BRUCE FRANKLIN		
AUDIO PROCESSOR MK2		
Bruce Franklin	Rev 1.1 5/27/15	Page 1 of 1

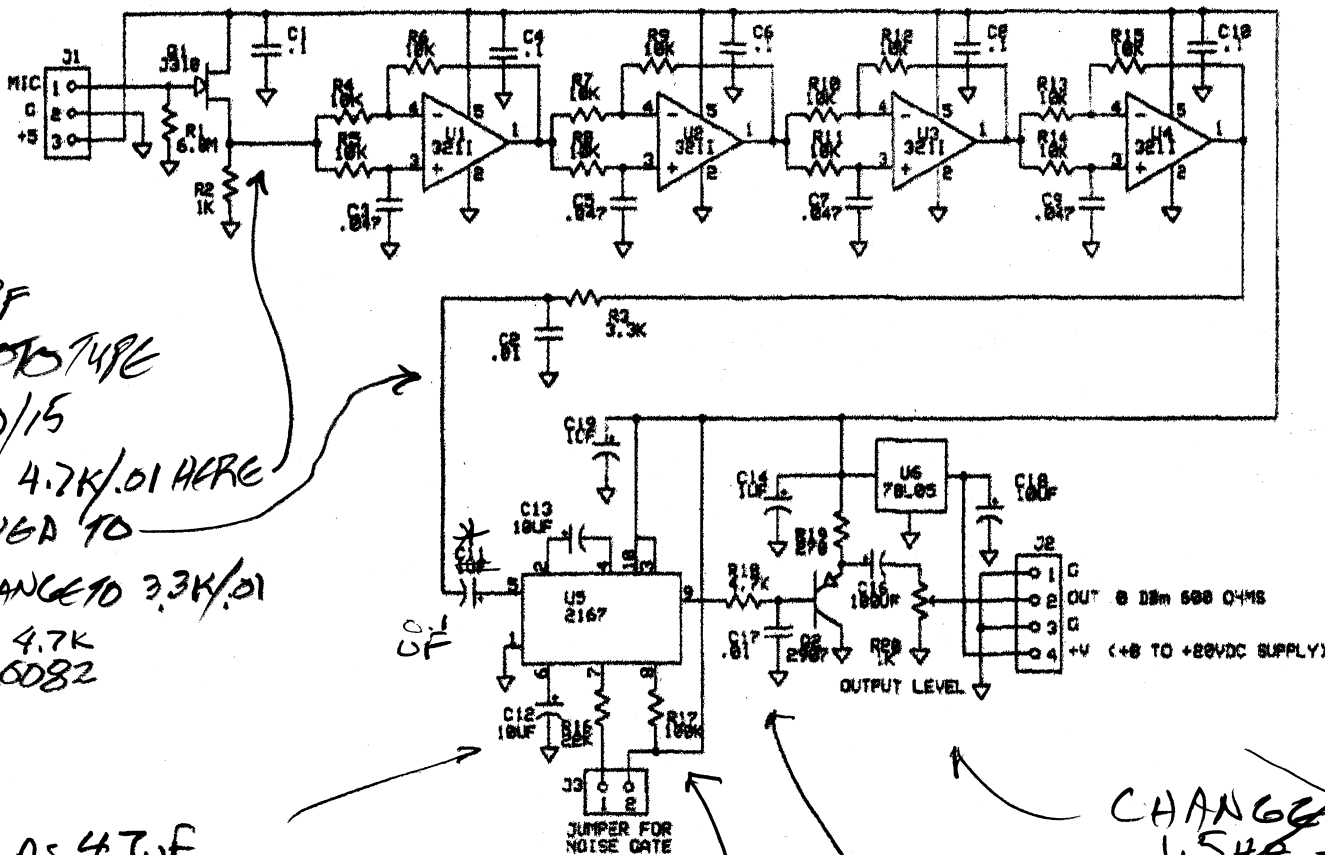
LPF  
PROTOTYPE  
3/20/15  
WAS 4.7K/OI HERE  
MOVED TO  
EXCHANGE TO 3.3K/OI  
C2 4.7K  
C2 0082

C12 WAS 47UF  
CHANGE TO 100UF

WAS 100UF ON ORIGINAL  
C11 CHANGE TO 0.1UF FROM 10F  
\* PER 2167 DATA SHEET  
LF NOISE

PUT 22K  
IN PAR. R17  
LPF  
SAME

~~CHANGE C16 100UF → 1UF  
1.54R → 150R~~ NO
